PENRITH CITY COUNCIL

MAJOR ASSESSMENT REPORT

Application number:	DA18/0488
Proposed development:	Demolition of Existing Structures & Construction of Six (6) Storey Residential Flat Building containing 41 Apartments with Communal Roof Top Terrace & Two (2) Levels of Basement Car Parking
Property address:	28 Hope Street, PENRITH NSW 2750 30 Hope Street, PENRITH NSW 2750 26 Hope Street, PENRITH NSW 2750
Property description:	Lot 35 DP 31239 Lot 36 DP 31239 Lot 34 DP 31239
Date received:	14 May 2018
Assessing officer	Gemma Bennett
Zoning:	Zone R4 High Density Residential - LEP 2010
Class of building:	Class 2 , Class 7a
Recommendations:	Refuse

PROPOSED ROOF TERRACE PLAN
Scale: 1:100

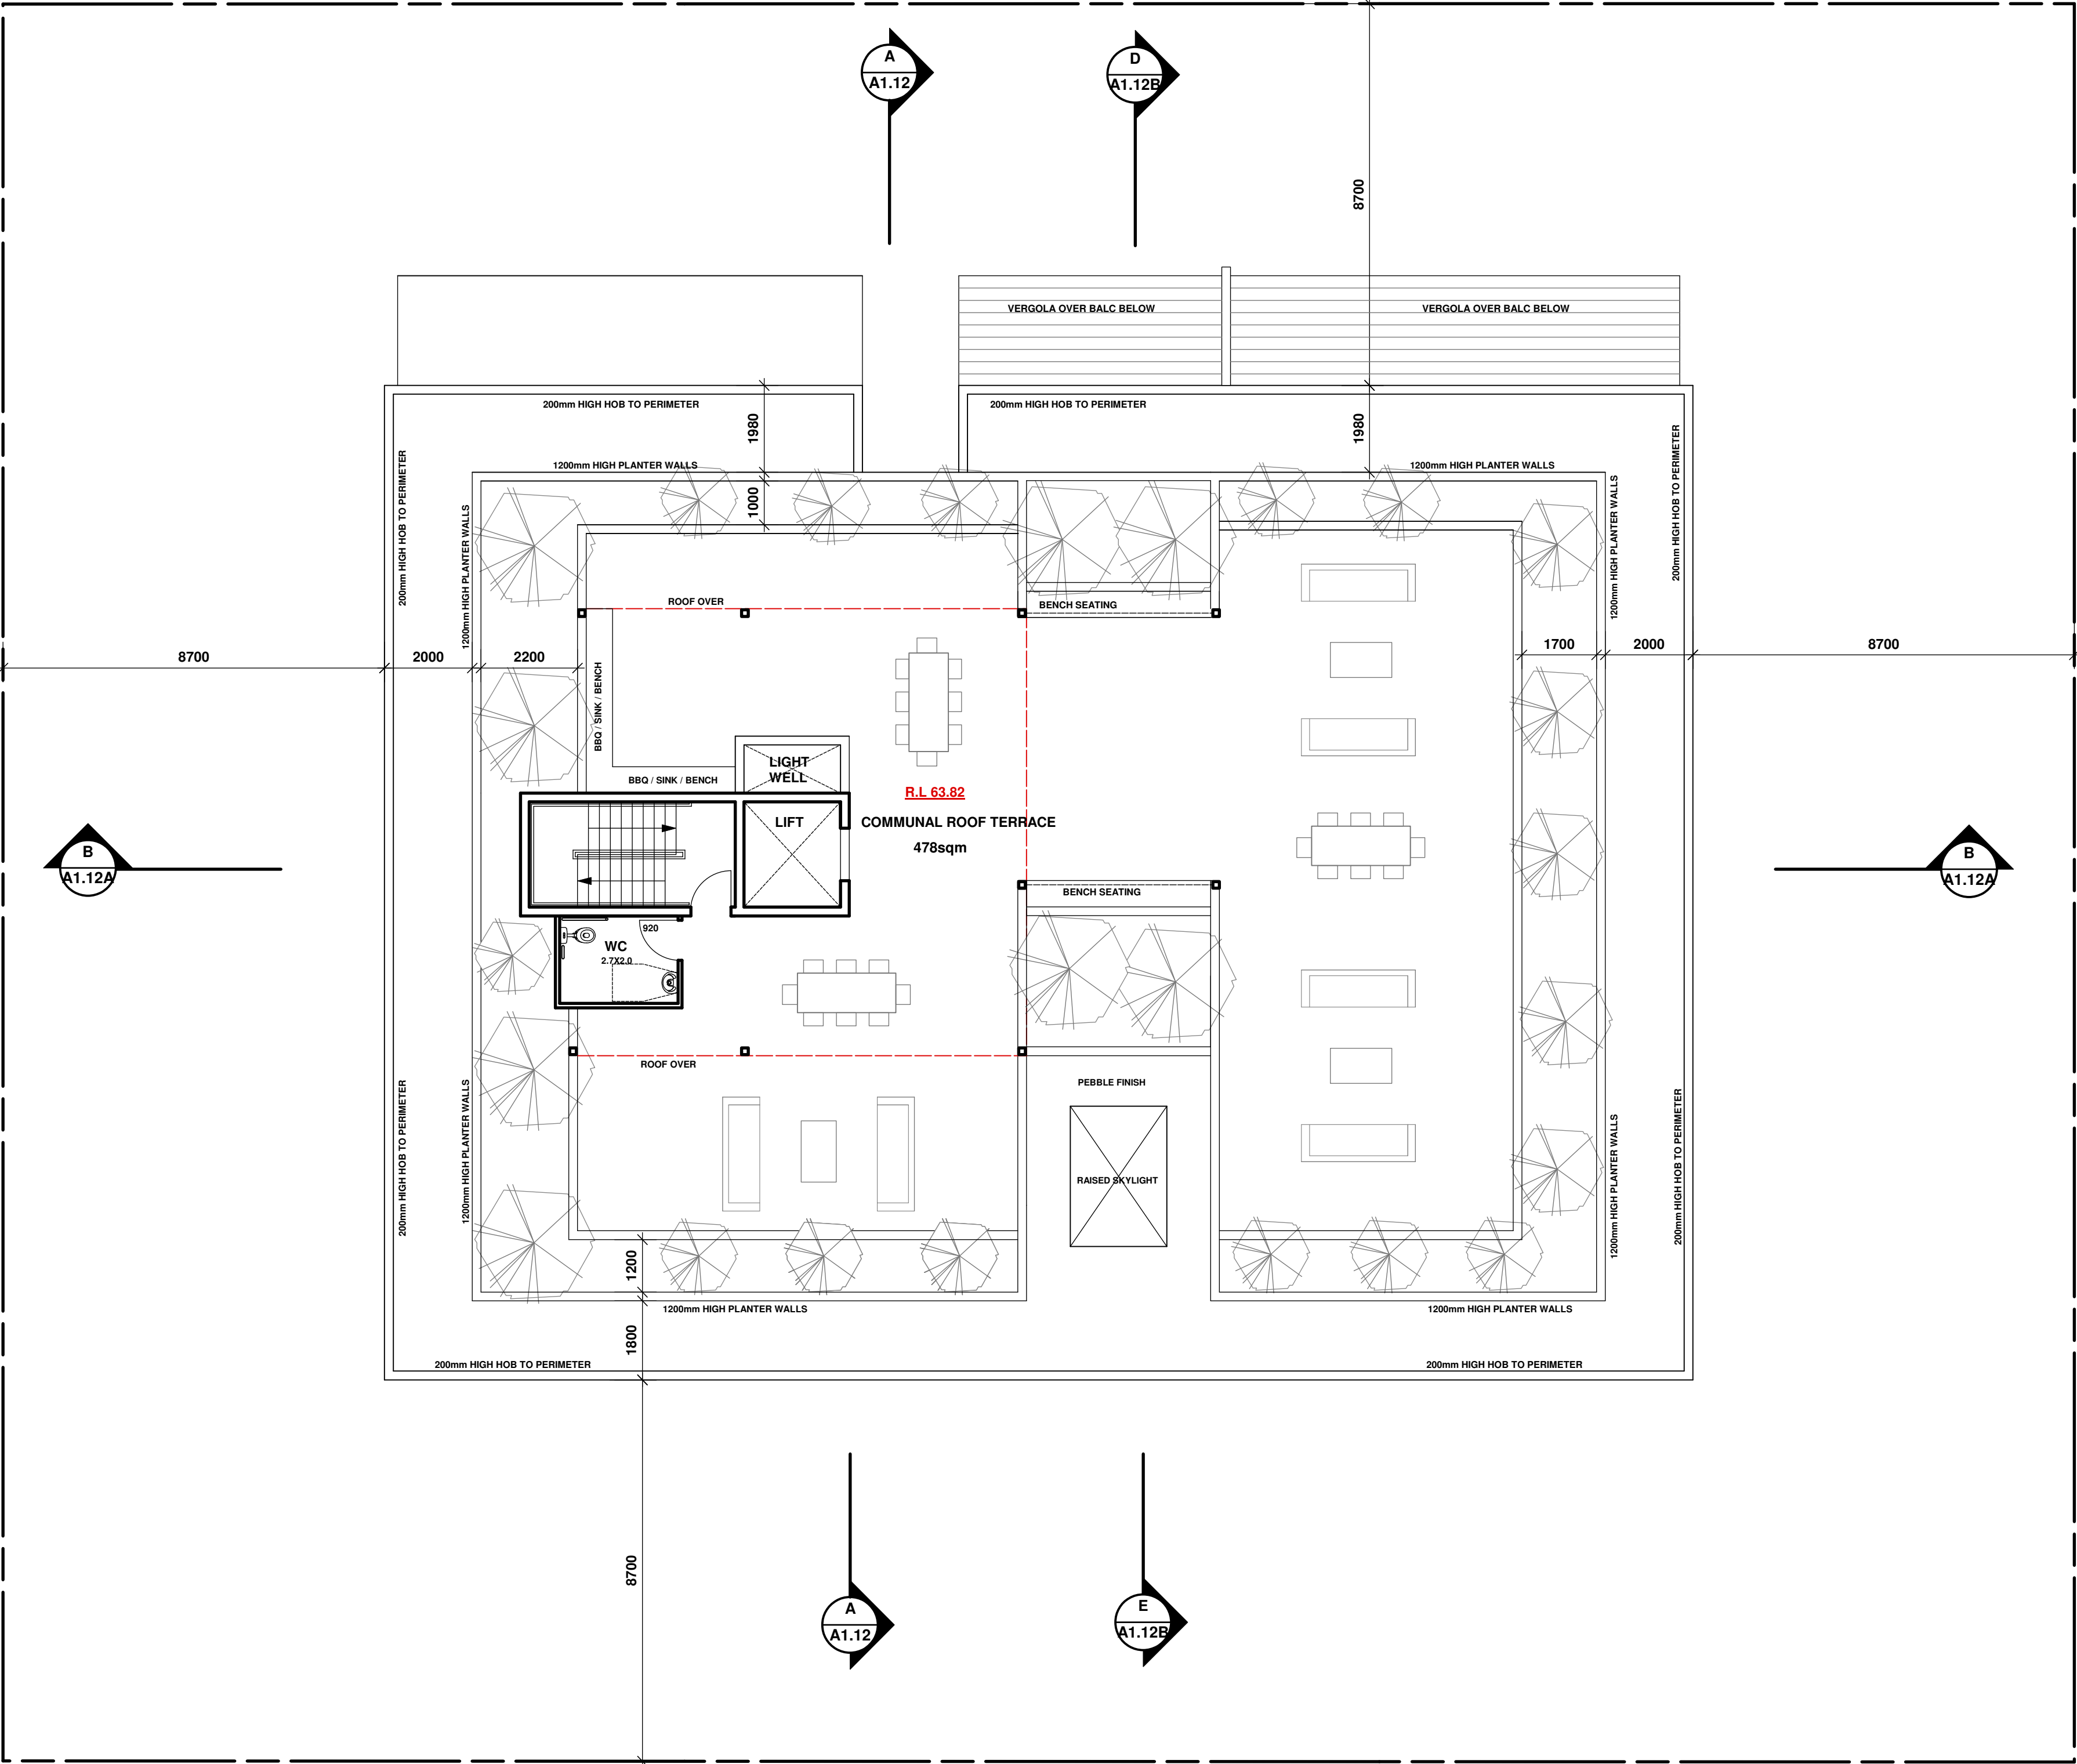
The communal open space to the roof level is considered to have been appropriately treated with landscaping features for the use of future occupants. These planter boxes are 1.2m in depth and are considered to allow for an appropriate mix of plant and tree species to assist in softening the presentation of this common area.

TITLE: **9AM-NOON SUN VIEWS**

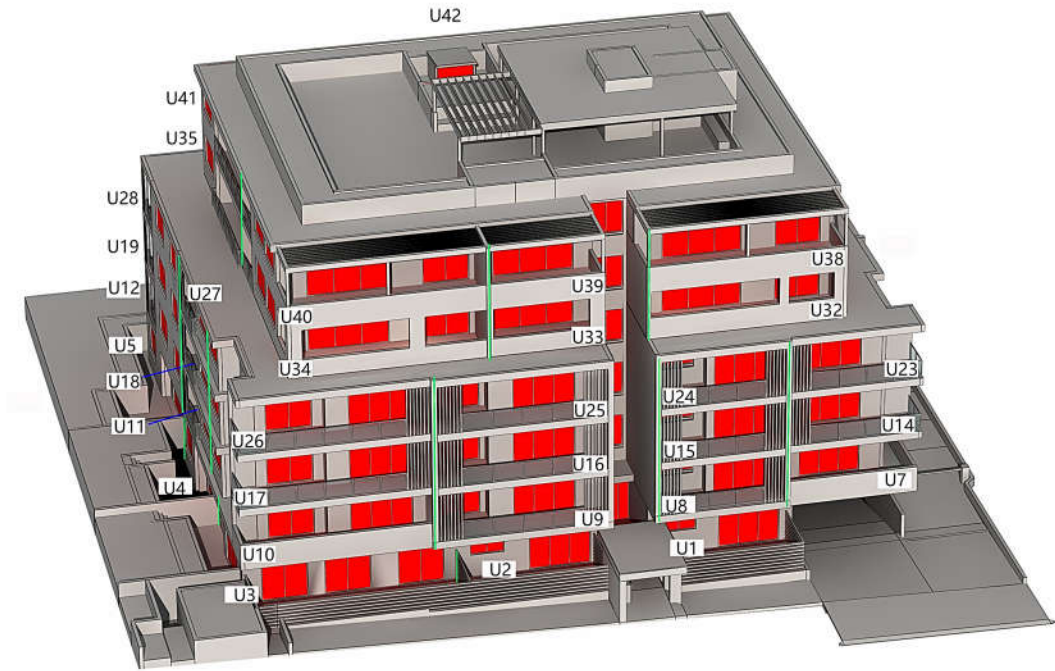
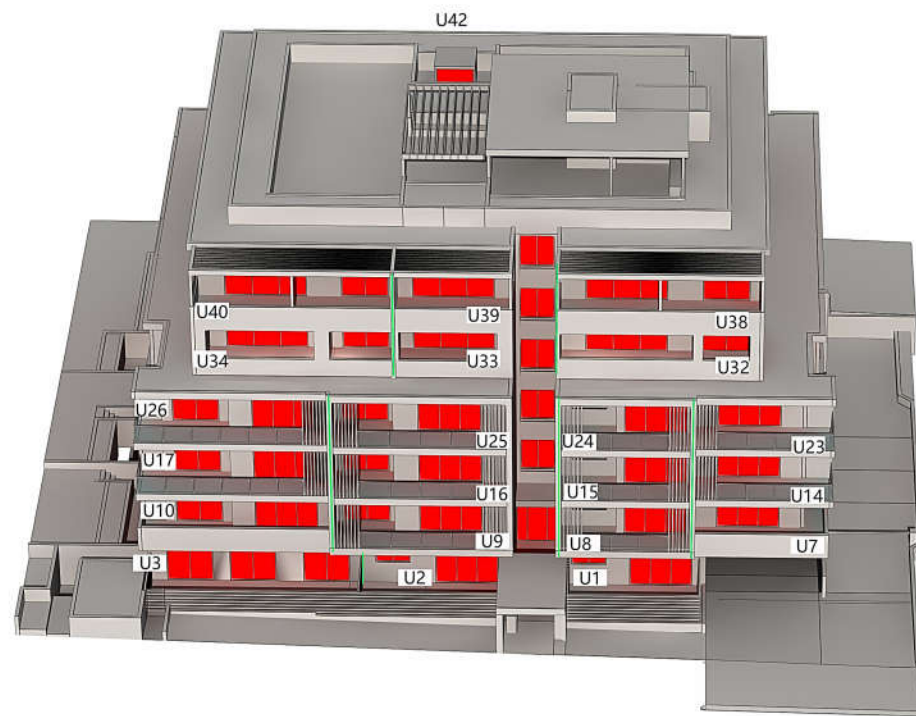
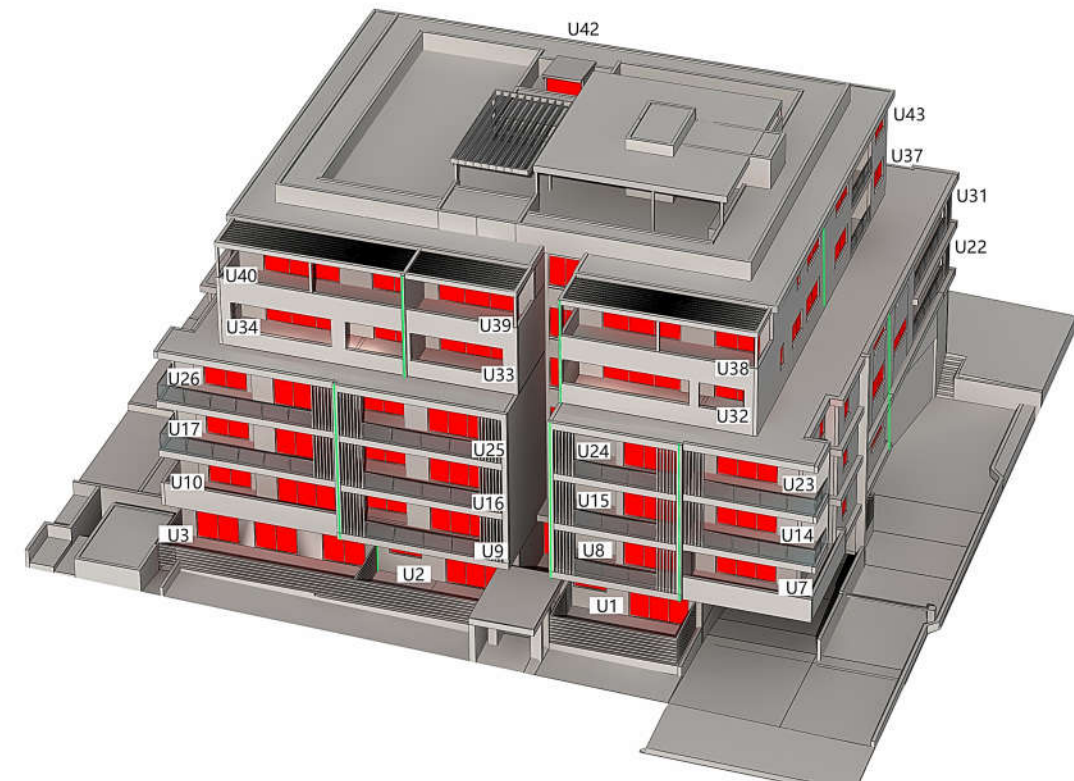
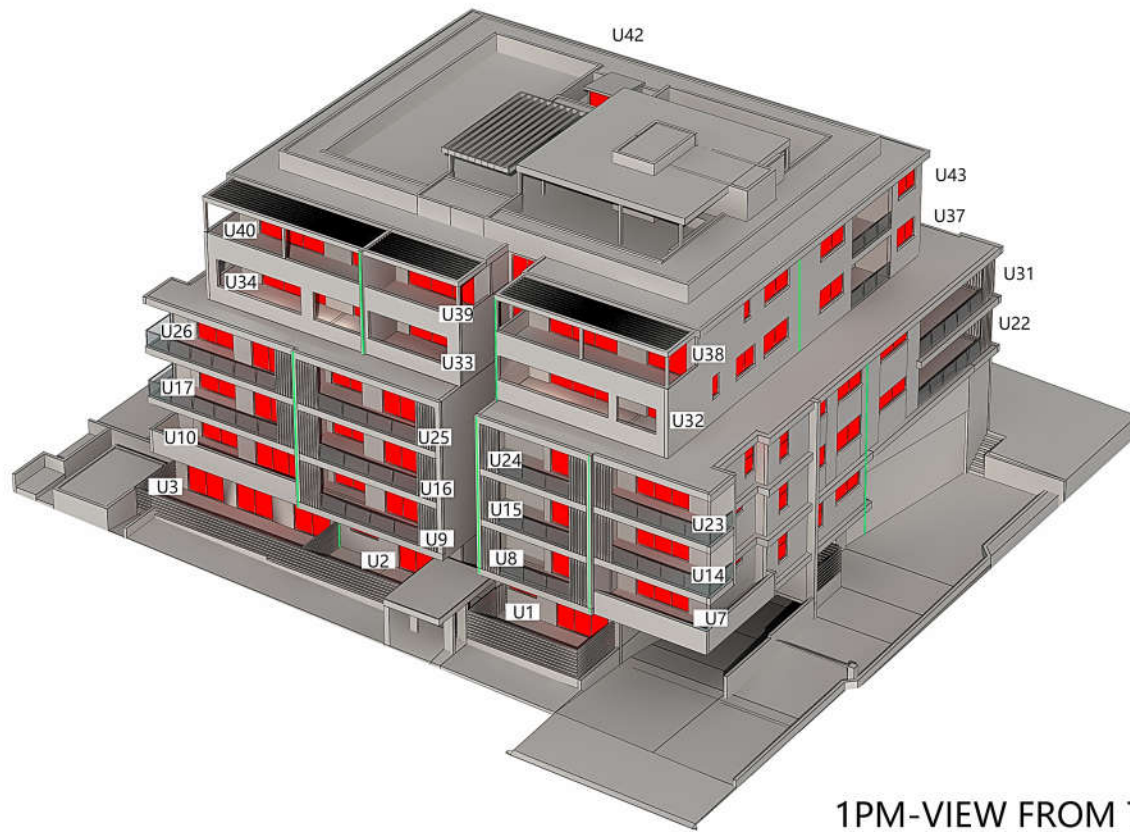
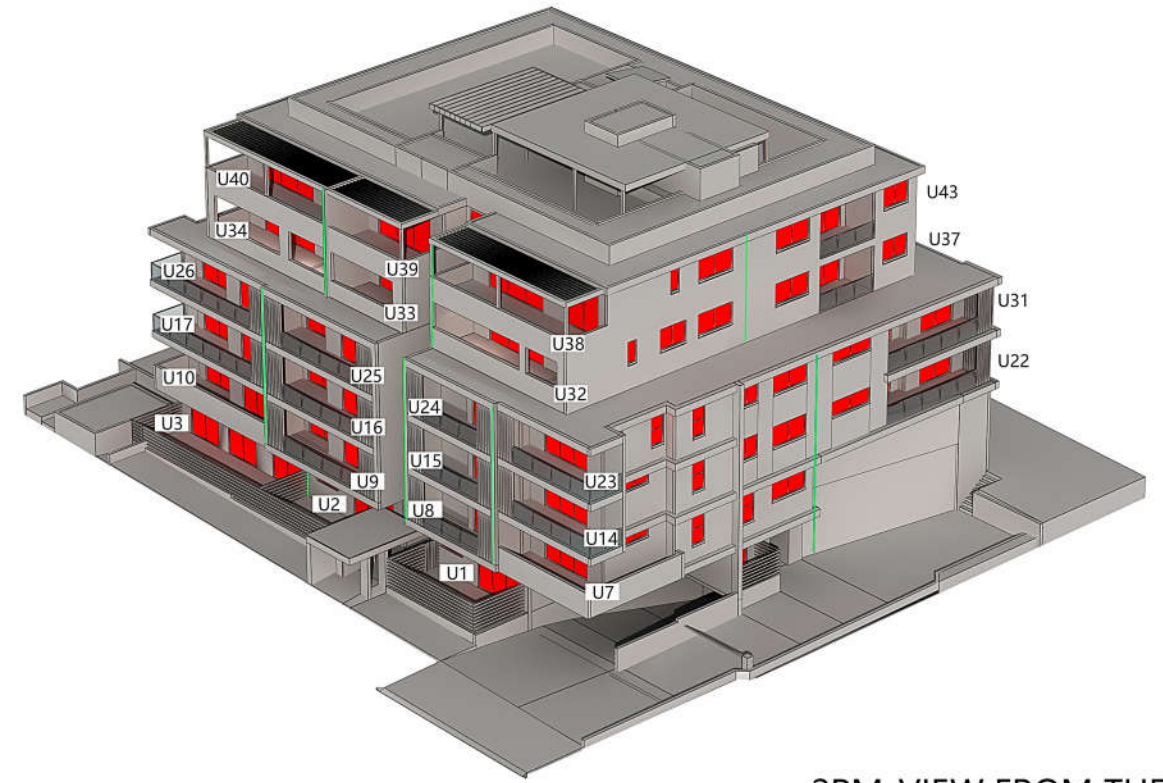
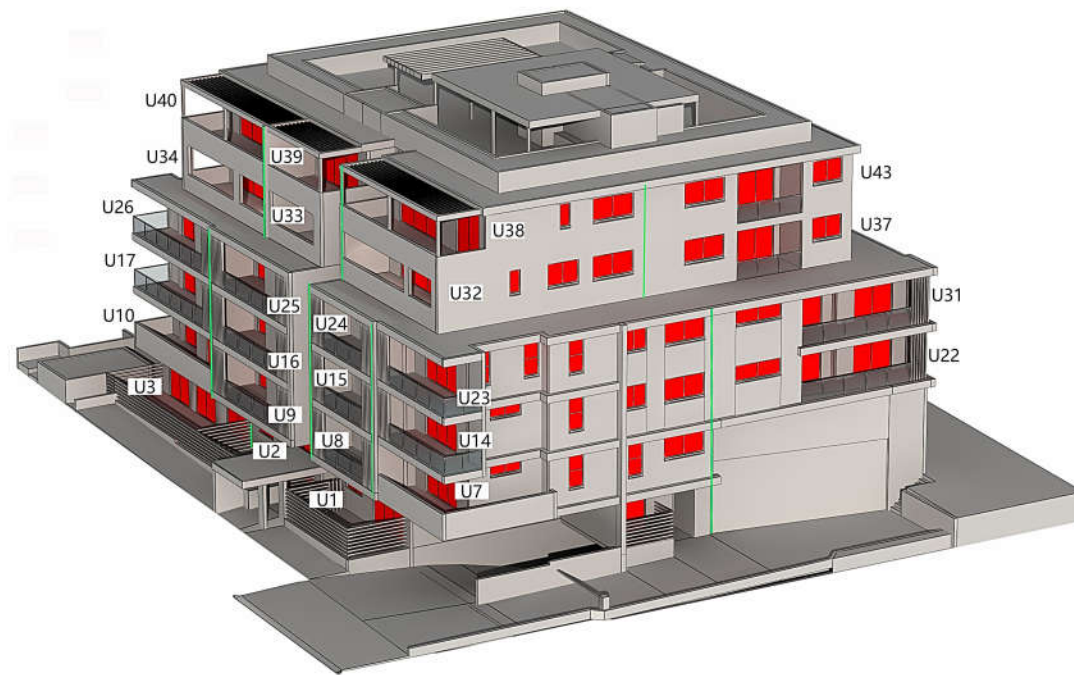
The application has been accompanied by architectural plans which are considered to identify that 26 of the proposed 41 units (a total of 63%) will achieve a minimum 2 hours solar access between 9 am and 3 pm at mid-winter and is therefore non-compliant with the solar and daylight access requirements as provided by the Apartment Design Guide. It is also noted that the ground floor unit 4 on the south east corner of the building is located below the existing ground level and will receive restricted solar access in this regard. It is also noted that this concern for unit 4 has been maintained from previous revised architectural plans.
